Access Compliance Report Public Rights-of-Way (Curb Ramps)

Main Street: RIBERA_RD		Cross Street: REATA_RD		Location:	E
ADA ID: RPRK211118132036	Ramp Type:Type 1 - Perpendicular	Initial Pass/Fail: Fail	Overall Compliance: No	Severity Score:	16

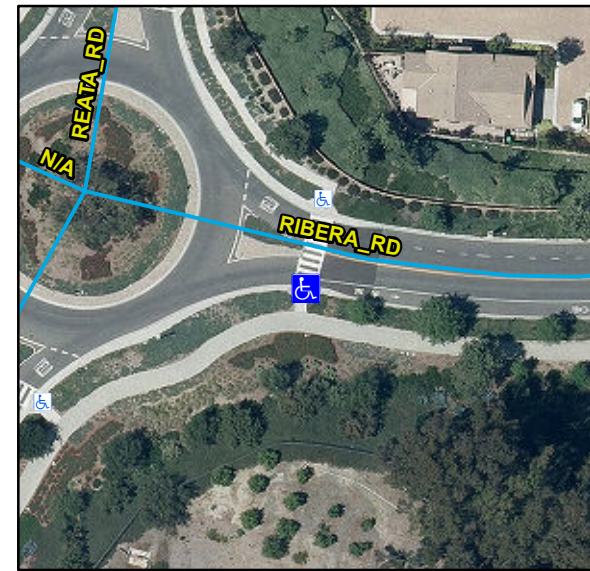
Compliance	Description	Data	Compliance	Description	Data
N/A	Ramp Length (in)	58	N/A	Flare Type LT	
Yes	Ramp Width (in)	60			N/A
No	Ramp Run Slope (%)	8.9	N/A	Flare Slope LT (%)	N/A
No	Ramp Cross Slope (%)	4.5	N/A	Flare Traversable LT	N/A
N/A	Landing Present	N/A	N/A	Flare Type RT	
N/A	Landing Length (in)	N/A			N/A
N/A	Landing Width (in)	N/A	N/A	Flare Slope RT (%)	N/A
N/A	Landing Run Slope (%)	N/A	N/A	Flare Traversable RT	N/A
N/A	Landing Cross Slope (%)	N/A	N/A	DWS Provided	N/A
N/A	Landing Movement Obstructed?	N/A	N/A	DWS Contrast	N/A
	Landing Movement Type	N/A	N/A	DWS Length (in)	N/A
N/A	Landing Shared	N/A	N/A	DWS Full Width	N/A
N/A	Clear Space	N/A	N/A	DWS Offset Left (in)	N/A
N/A	Clear Space To Crosswalk (in)	N/A	N/A	DWS Offset Right (in)	N/A
N/A	Marked Crosswalk 1	Yes	N/A	Marked Crosswalk 2	N/A
	Crossing 1 Direction	NE		Crossing 2 Direction	N/A
	Marked Crosswalk 1 Width (in)	144		Marked Crosswalk 2 Width (in)	N/A

N/A	Ramp Inside Crosswalk 1	Yes	Yes	Ramp Inside Crosswalk 2	N/A
	Crossing 1 Slope (%)	0.3		Crossing 2 Slope (%)	N/A
	Crossing 1 Cross Slope (%)	3.1		Crossing 2 Cross Slope (%)	N/A
N/A	Gutter Ponding	N/A	No	Curb Slope	5.5
Yes	Gutter Lip Height (in)	0		Road Run Slope (%)	N/A
N/A	Gutter Run Slope (%)	N/A		Road Cross Slope (%)	N/A
N/A	Gutter Cross Slope (%)	N/A			
Yes	Overall Surface Condition: Acceptable		Yes	Perp Joint Present	Yes
	Cross Gutter Present?	No		Spandrel Present?	No
	Replace Cross Gutter?	N/A		Replace Spandrel?	N/A

Remove & Replace Entire Ramp.

R304.2.2, R304.5.3, STD 1115
